RAI Volume 2, Chapter 2.1.1.4, Third Set, Number 1, Supplemental Question 9:

1. RESPONSE

1.1 EMPLACEMENT DRIFT ROCK BOLT DESIGN BASES

Figure 1. Temperatures at 600 m from Emplacement Drift Inlet

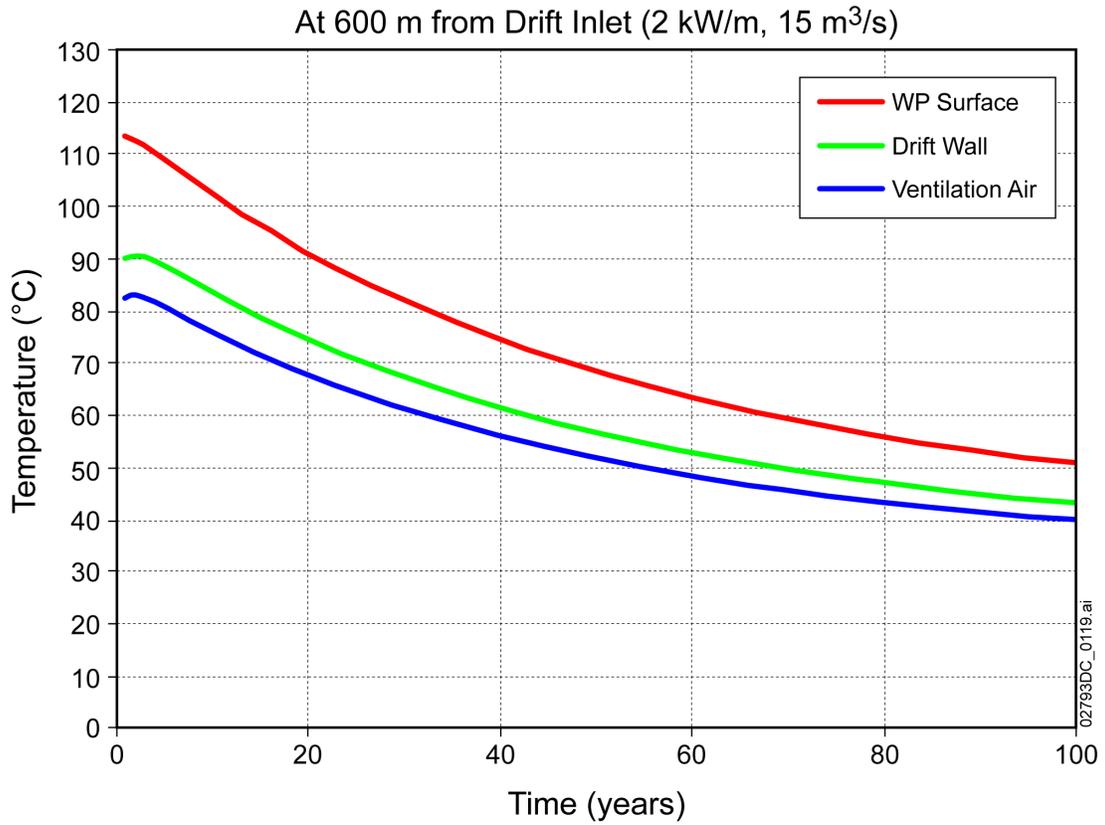
Where in the SAR is (or provide information on) potential susceptibility of rock bolts to stress corrosion cracking or crevice corrosion? This could happen under varying relative humidity (10% to 80%) and aqueous chemical conditions (e.g., salt precipitation) along their longitudinal direction.

Temperature—As reported in *Preclosure Emplacement Drift Temperature Calculation for the 2.0 kW/m Thermal Load* (BSC 2008c)¹, Figures 1 and 2 show the estimated emplacement drift wall temperatures for drift lengths of 600 m and 800 m for the repository design basis 2.0 kW/m thermal line load with a continuous 15 m³/s ventilation airflow rate. These drift wall temperature estimates are conservative because they are based on simulation of the repository's thermal response assuming that the waste package inventory (70,000 MTMH) is emplaced simultaneously at the time subsurface ventilation is initiated (year 0 in Figures 1 and 2), as opposed to the expected waste emplacement phased over a period of up to the first 50 years of operations for which the duration, timing, and peak values of drift wall temperatures would be less significant relative to stress corrosion cracking conditions. A temperature drop of about 10°C to 20°C was estimated for 1 to 3 m into the host rock (BSC 2008a, Section 6.4).

Based on the discussions below, stress corrosion cracking and crevice corrosion are unlikely to occur at temperatures below approximately 70°C in the repository environment, but cannot be excluded from occurring at temperatures above 70°C. Information presented in Figures 1 and 2 includes the estimated emplacement drift wall temperatures during preclosure for typical and maximum drift lengths. The average emplacement drift length is approximately 600 m, and the longest drift approaches 800 m in length. As shown in Figures 1 and 2, the drift wall temperatures peak immediately after emplacement and decrease steadily thereafter. For a 600 m long emplacement drift, the wall temperature drops below 70°C less than 30 years after initial emplacement; and for an 800 m long drift, the drift wall temperature drops below 70°C a little more than 40 years after initial emplacement. For the first 350 m of emplacement drift, the drift wall temperatures will not exceed 70°C during the preclosure period (BSC 2008c, Figures 3 and 4). Though stress corrosion cracking cannot be excluded from occurring at temperatures above 70°C, any stress corrosion cracking is expected to be localized and is not expected to affect the overall support characteristics of the Swellex-type rock bolts.
